CLAREMONT BUSINESS PARK 2 FILING NO. 2

CONSTRUCTION PLANS

V1_CDs Redlines.pdf Markup Summary

Glenn Reese - EPC Stormwater (15)

STORM SEWER PLAN & PROFILE

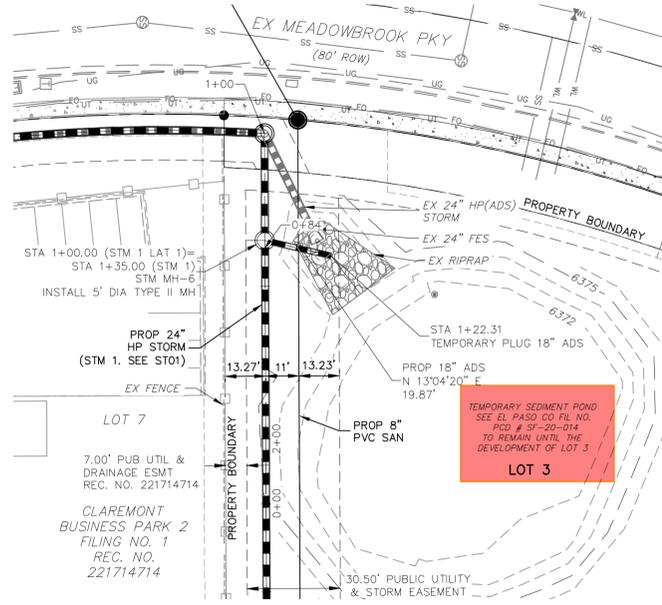
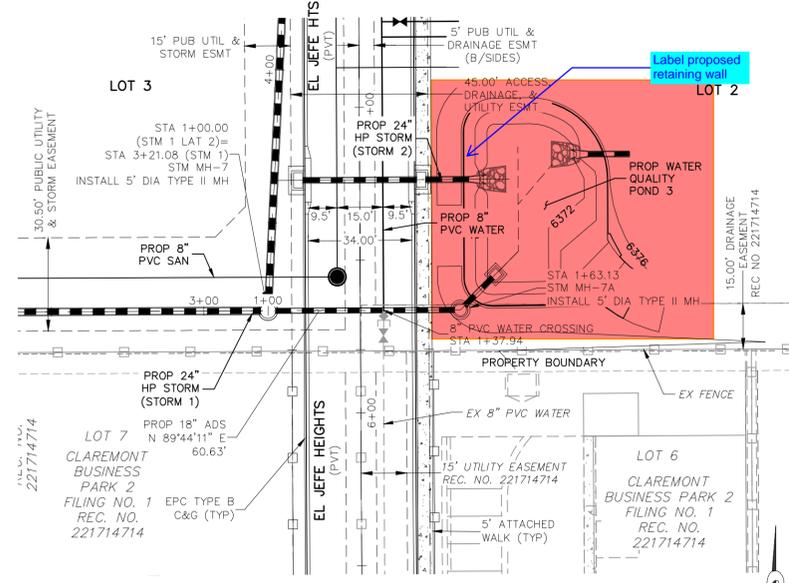
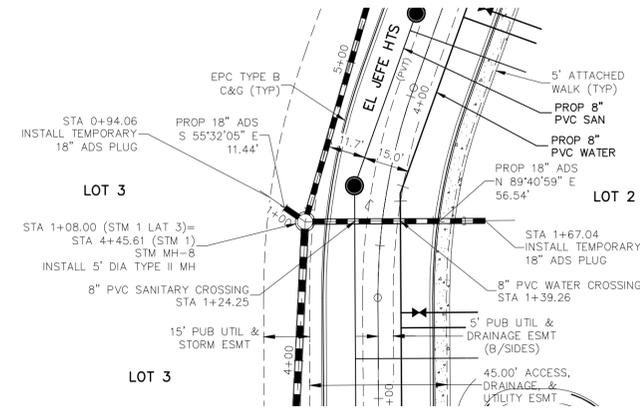
Show and label wall (To show if pipe does or doesn't need to go through wall)

STORM SEWER PLAN & PROFILE

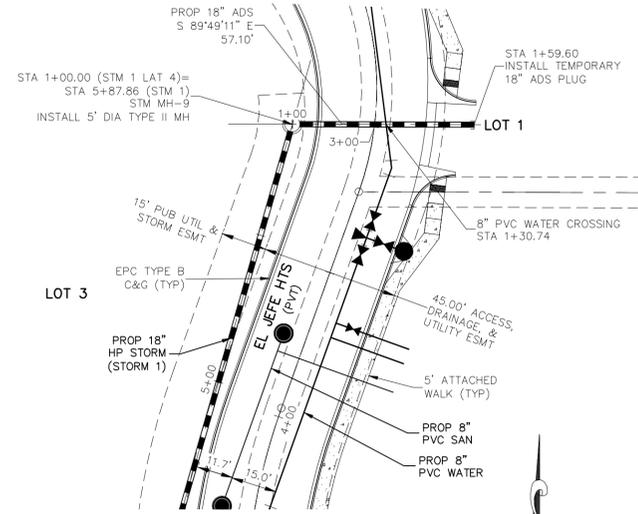
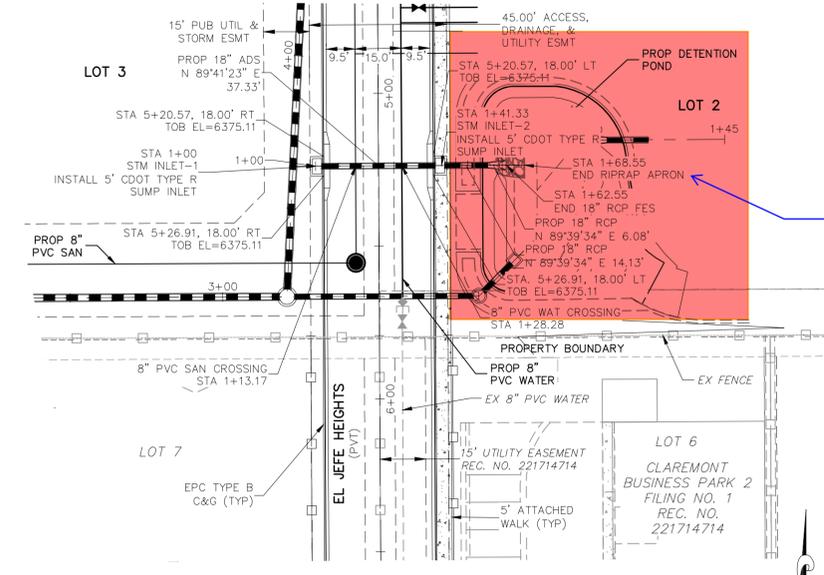
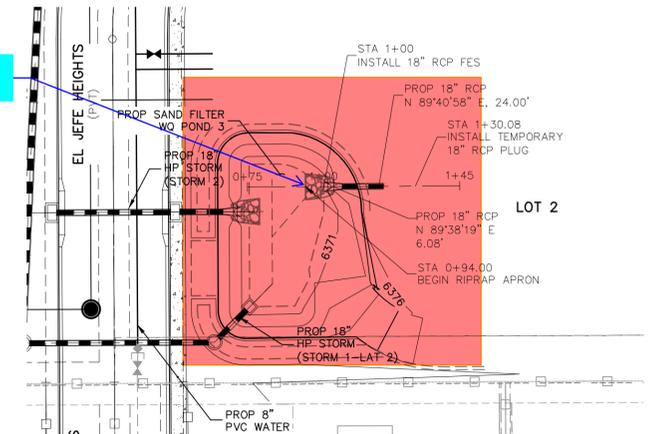
Reference sheet for apron detail

MAINTENANCE & ACCESS ROAD ABOVE EURV TYPICAL SECTION
NOT TO SCALE

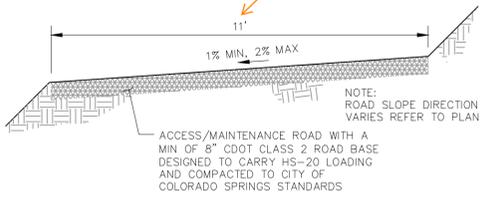
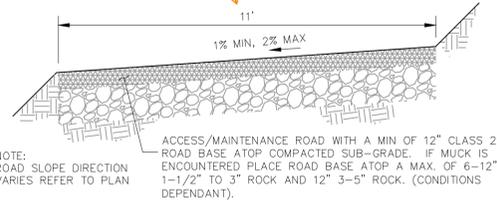
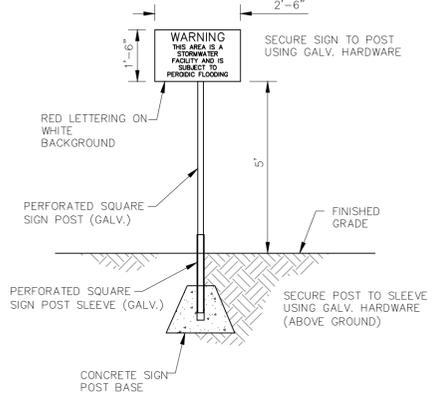
Plan dwg on next page show width of access road at ~30ft. Revise to remove discrepancy.
Stabilized access ramp shall be a minimum of 15ft wide and no greater than 12% slope, in accordance with DCMv1, Chap 11.2.2. As I think you know, it may be acceptable to design the access road with a thinner width if the anticipated maintenance vehicles and equipment can still safely access the pond and reach structures. Properly document this in the Pond O&M manual.

Out of order? Move to after BMP01?

Plan dwg on next page show width of access road at ~30ft. Revise to remove discrepancy.

Stabilized access ramp shall be a minimum of 15ft wide and no greater than 12% slope, in accordance with DCMv1, Chap 11.2.2. As I think you know, it may be acceptable to design the access road with a thinner width if the anticipated maintenance vehicles and equipment can still safely access the pond and reach structures. Properly document this in the Pond O&M manual.

MODIFIED CDOT TYPE C WATER QUALITY OUTLET BOX AND SAND FILTER
SECTION A-A
 NOT TO SCALE

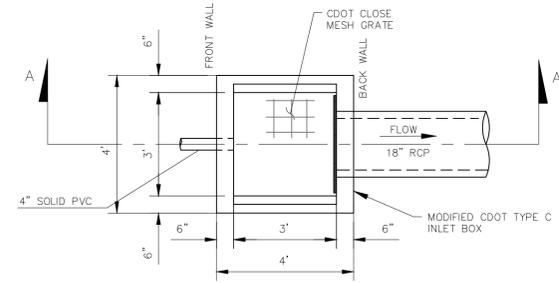
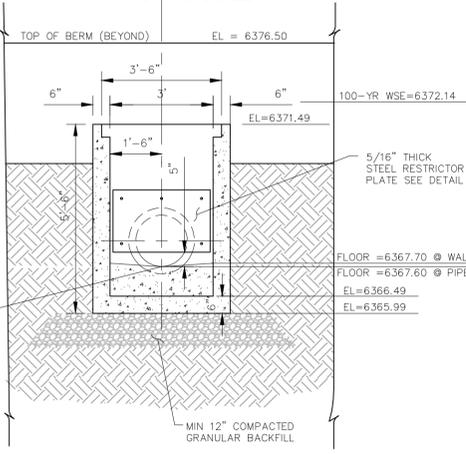
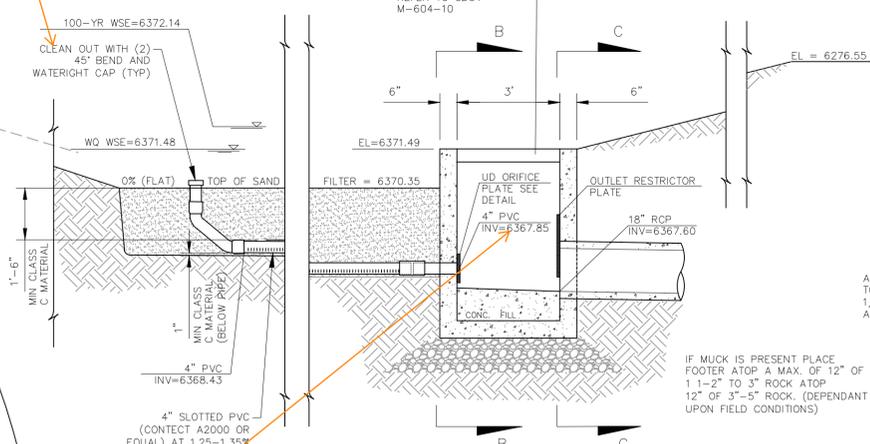
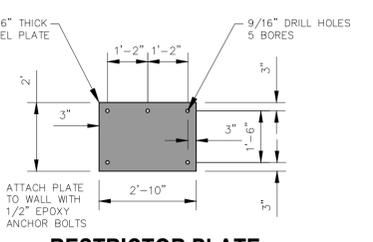
clarify that the cleanout is to be 4" PVC straight pipe (not slotted like the rest of the underdrain)

revise to lower detail to match "6367.85" provided in upper detail, which matches MHFD-Detention spreadsheet.
